# Groundwater Application Review Summary Form

Application # G- 18729

TO: Water Rights Section Date 3/27/2019  
 FROM: Groundwater Section Travis Brown  
 Reviewer's Name  
 SUBJECT: Application G- 18729 Supersedes review of \_\_\_\_\_  
 Date of Review(s)

**A. GENERAL INFORMATION:** Applicant's Name: Charles Christensen County: Clackamas

Well Location Map

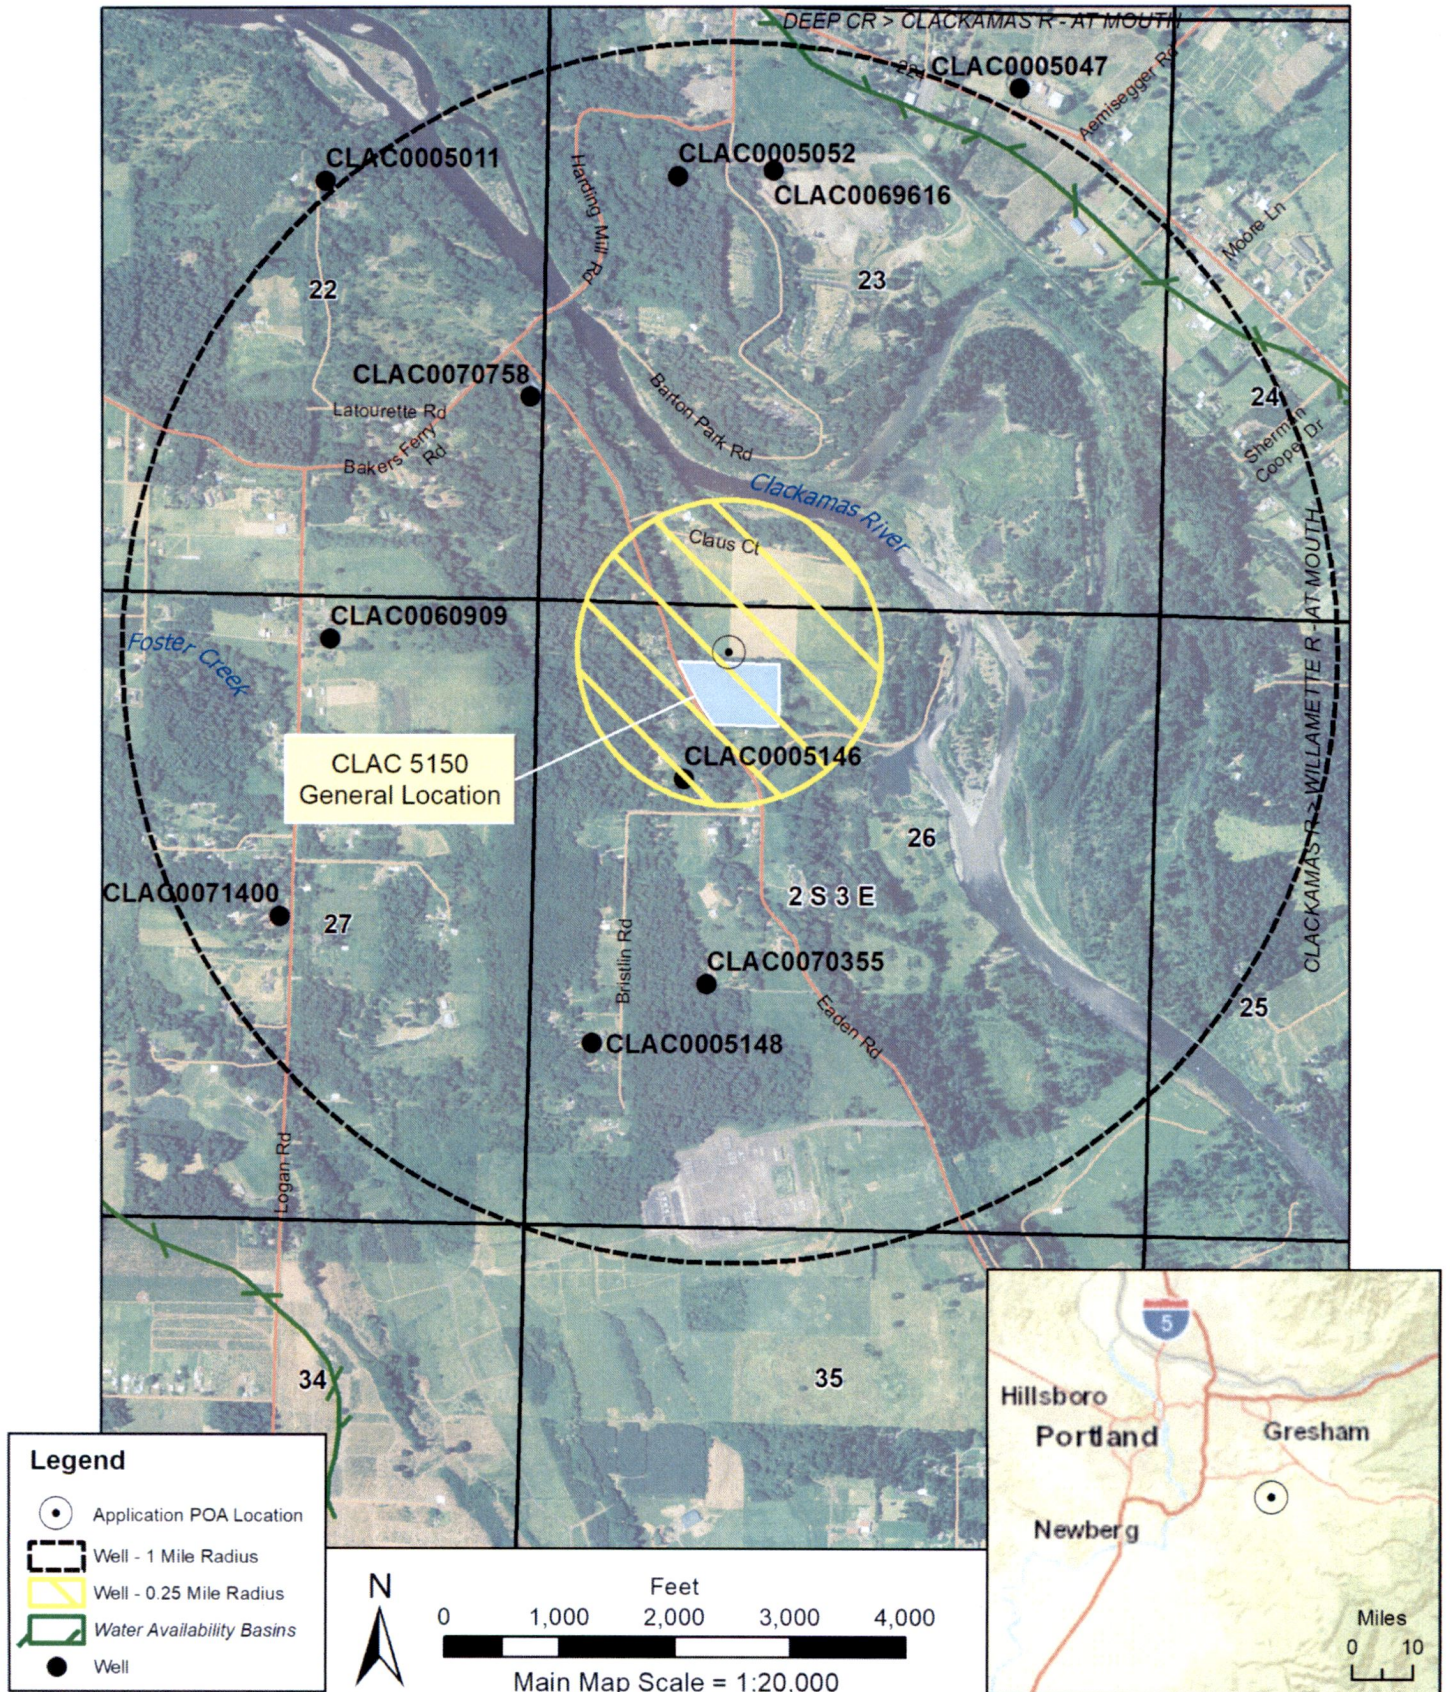
Review of nearby domestic/exempt wells indicated one well which may be in close proximity to the proposed POA (see Well Location Map, attached). The water well report for CLAC 5150 indicates its location as in 2S/3E-26 NE-NW (the same quarter-quarter as the proposed POA) on Tax Lot 202, the nearest edge of which is ~320 ft south of the proposed POA (the furthest edge is ~770 ft from the proposed POA). However, CLAC 5150 is registered to owner Allen S. Crandall; Tax Lot 202 is registered to James & Linda Bohl, while Tax Lot 205 (north adjacent of 202) is registered to Allan and Kathleen Crandall. CLAC 5150 may therefore actually be located on Tax Lot 205, the nearest edge of which is only ~90 ft south of the proposed POA. CLAC 5150 is reportedly completed to 280 ft bls and screened from 270 to 280 ft bls. The proposed POA would also be completed to ~280 ft bls and screened from ~180 to 280 ft bls. As such, it is very likely the proposed POA

would tap the same water-bearing zone(s) as CLAC 5150. Due to significant uncertainty regarding the exact location of CLAC 5150 and the hydraulic parameters of the subject aquifer, the degree of interference with CLAC 5150 likely to result from pumping the proposed POA cannot be well-constrained; therefore, the preponderance of evidence cannot support a definitive conclusion that groundwater for the proposed use will not be available in the amounts requested without injury to prior water rights. **However, there is a significant potential risk that pumping the proposed POA at the requested maximum rate may cause substantial interference with CLAC 5150.**

Static Water Levels Graph

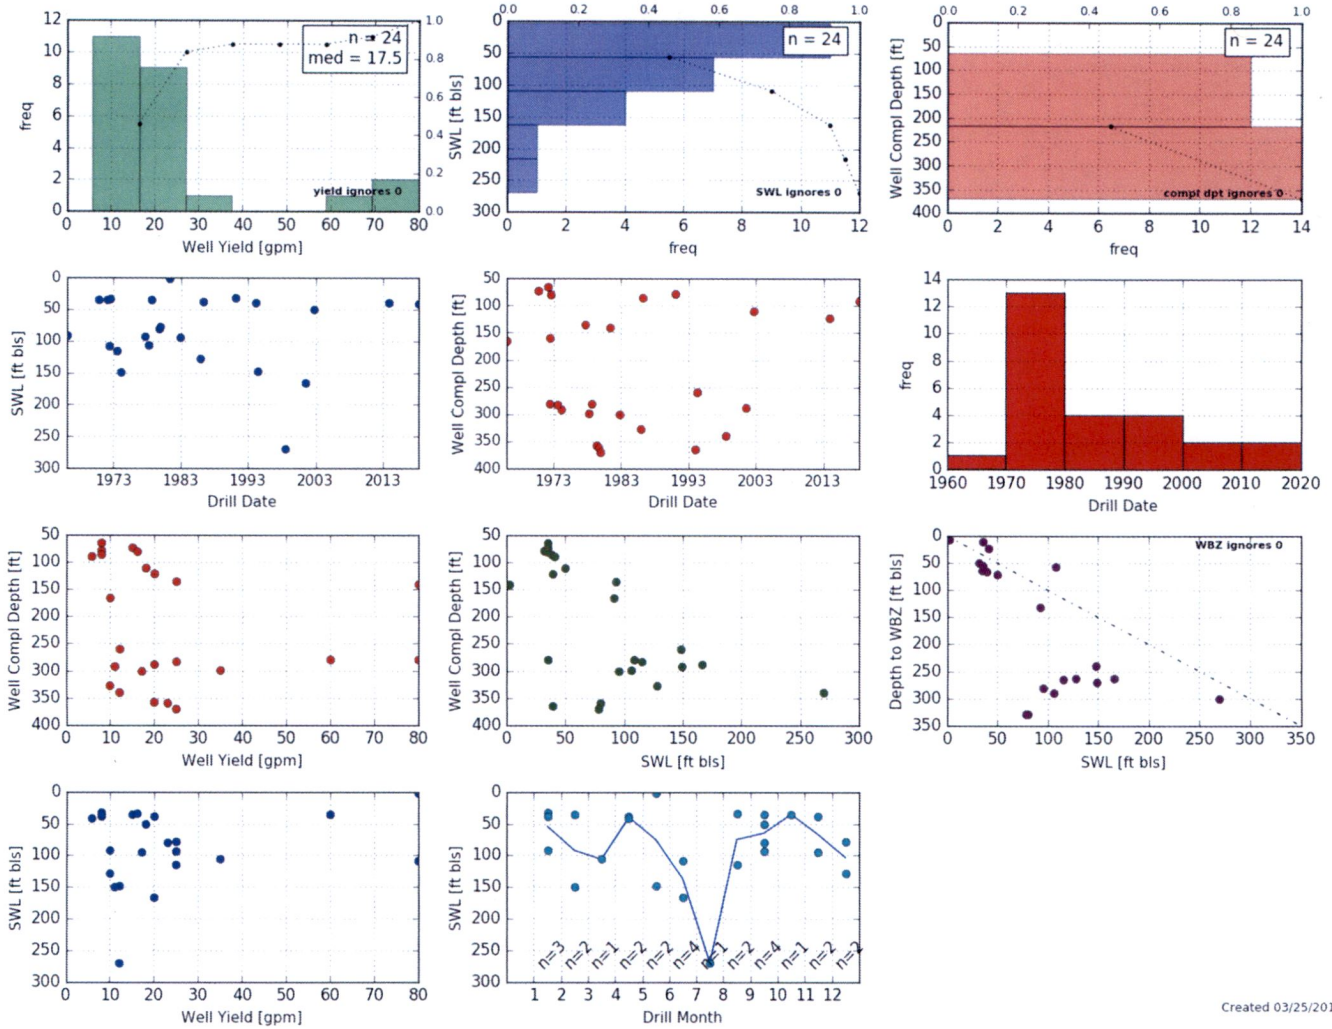
There do not appear to be any applicable observation wells with a significant period of record near the proposed POA. Reported static water levels (SWLs) from nearby water well reports range in elevation from ~166 to 290 ft above mean sea level (amsl) (see Static Water Levels Graph, attached), which would correspond to a range of ~64 ft bls to ~60 ft above land surface at the proposed POA. Static water levels therefore appear to vary significantly – on roughly the same order as topography – in the vicinity of the proposed POA. Analysis of reported SWLs and Well Completion Depths does not indicate a trend of either lowering SWLs or deeper well completions over time. **Therefore, based on the available information, it cannot be determined whether water levels are declining in the water-bearing zones of the Sandy River Mudstone.**
